WALNUT CREEK ADDITION
(DRAINAGE)

PROJECT WALNUT CREEK AODN

REFERENCE FINAL DRAINAGE PLAN

**CONFIRMATION
MEMO**

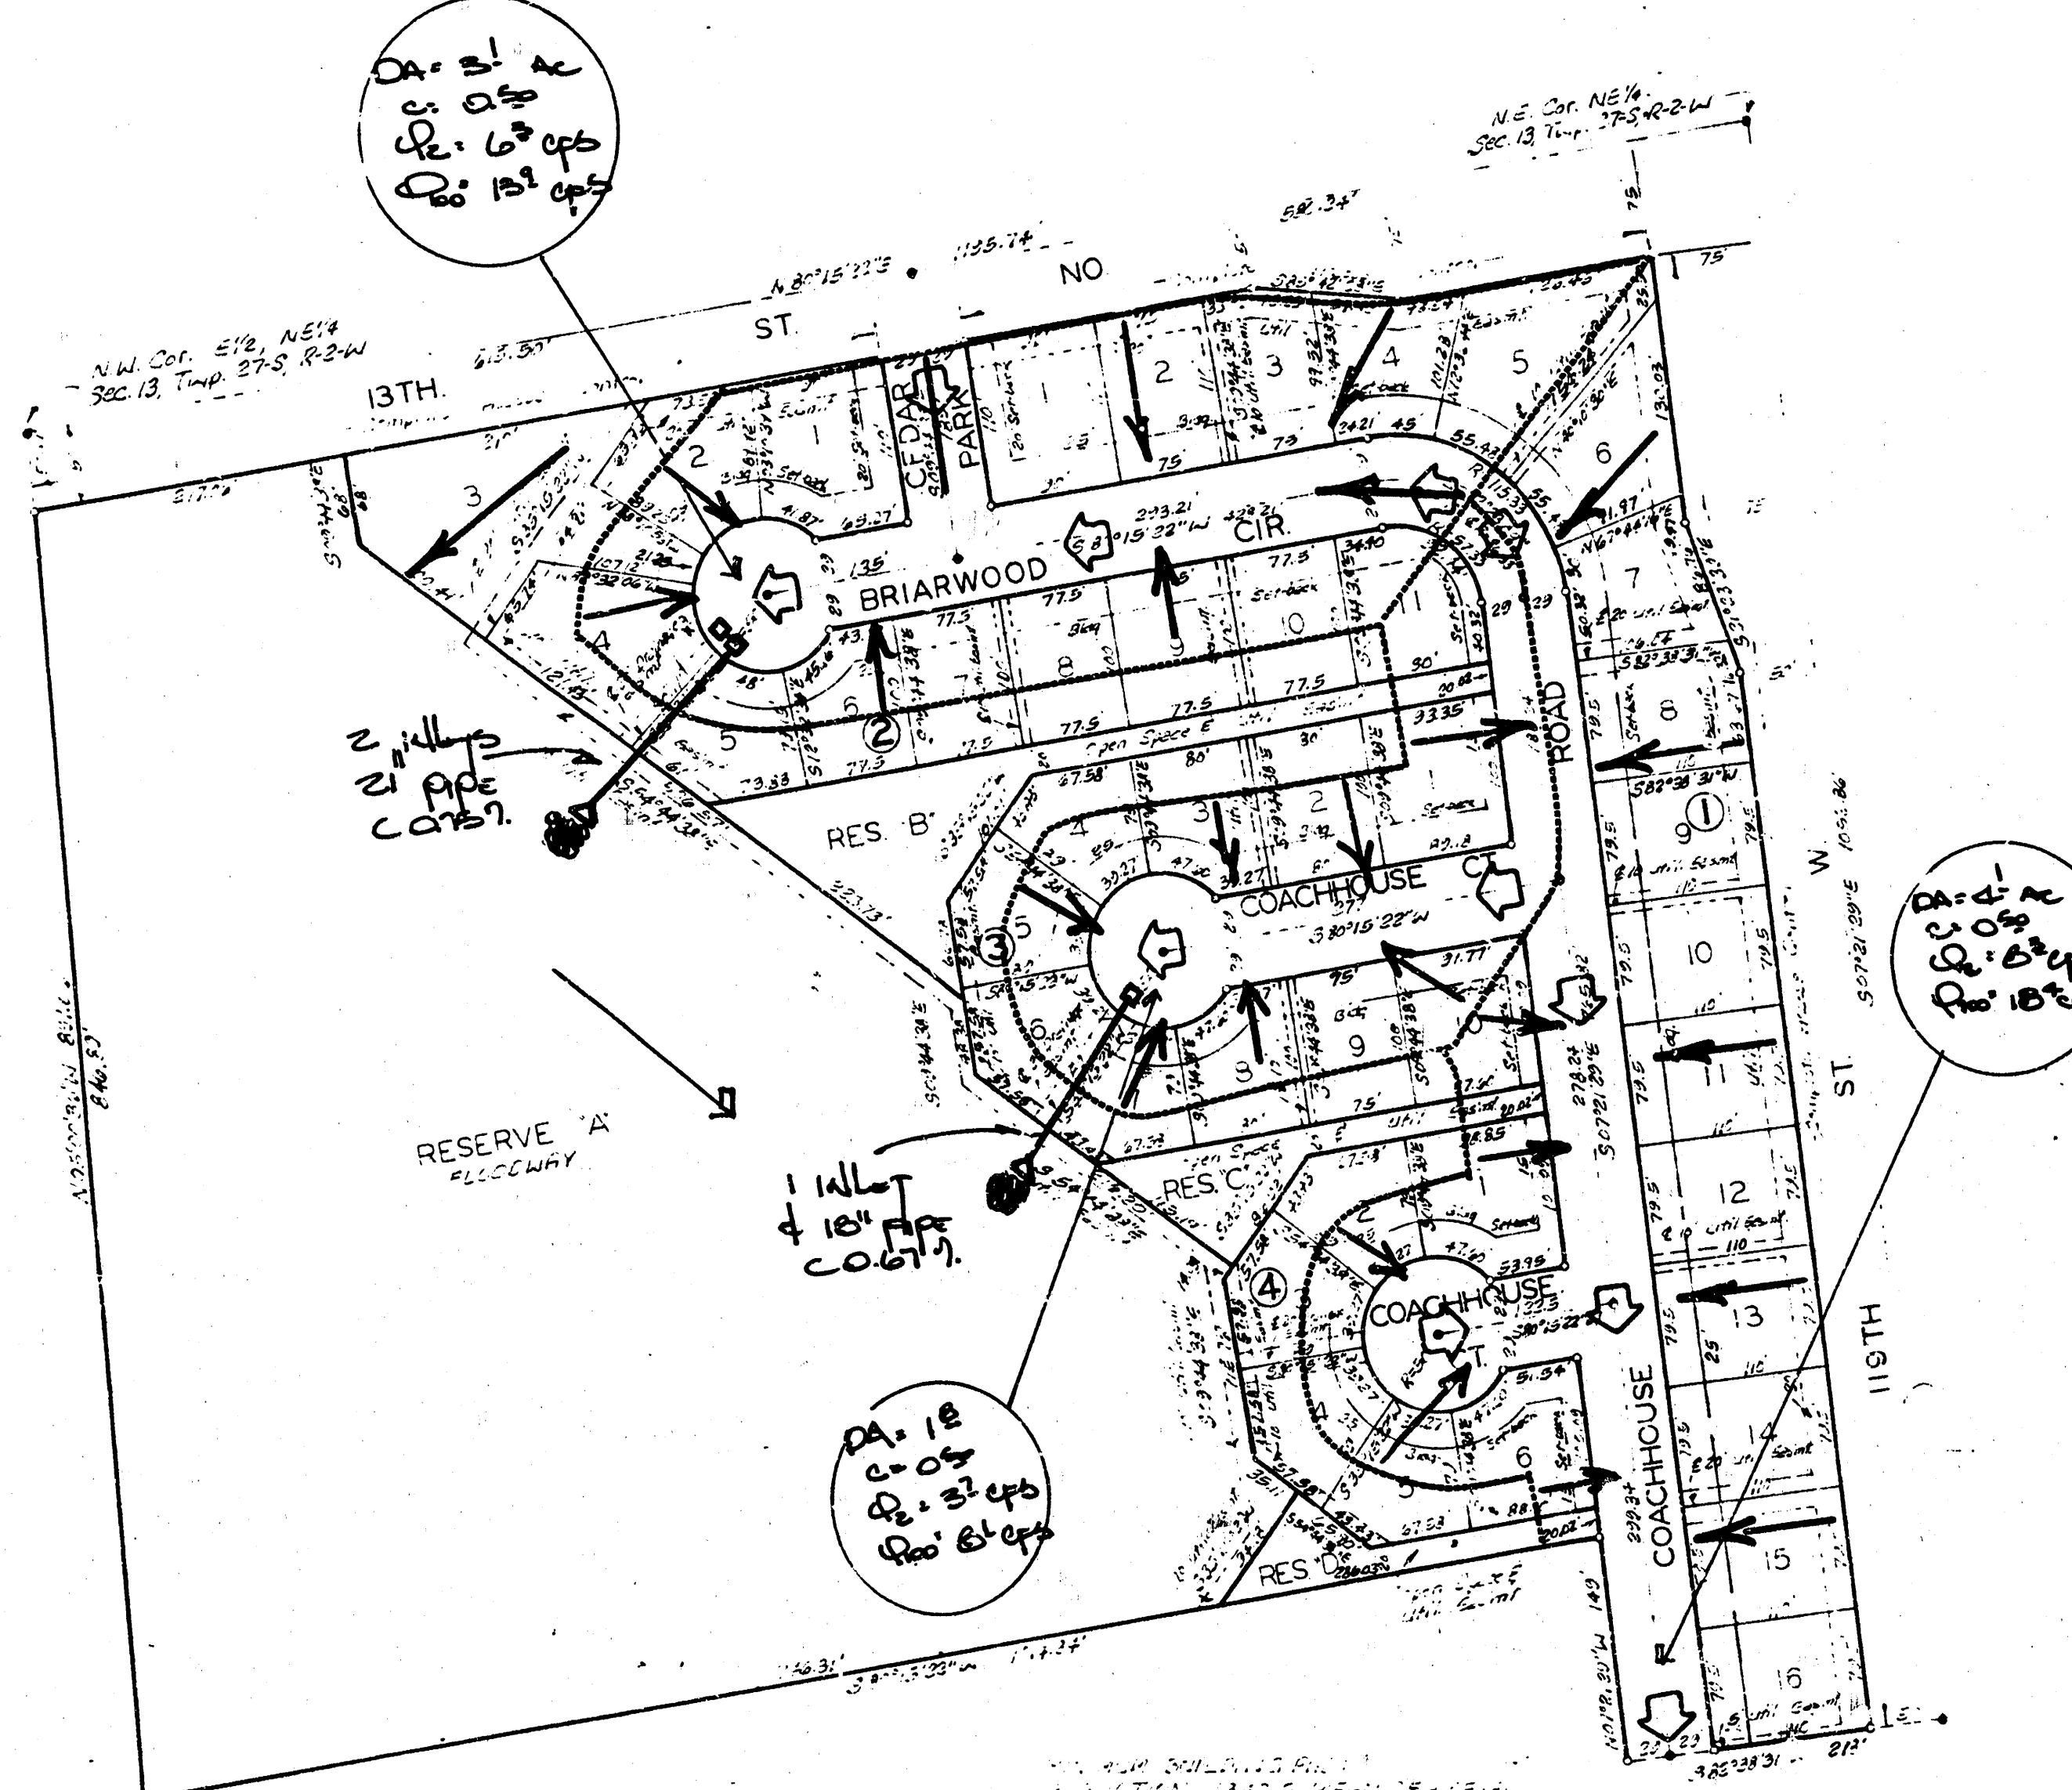
A) Drainage plan acceptable. Need guarantee of SWS.

lots still extend into floodway
Rear lot lines should conform
to floodway boundaries.

Requires offsite drainage easement
to drain Cooshoouse Road south
to creek

B) SS layout acceptable (extend ^{Brown}
 (Browned also very close) down from east
 Bldg set back = waiting 2 weeks B/LK 12.3.9; etc.
 * Request action! R/W on SS 13th

- * near bridge
- * lot 3 frontage (14.8' at creek)
- * Change platons text to read "appropriate governmental agency"
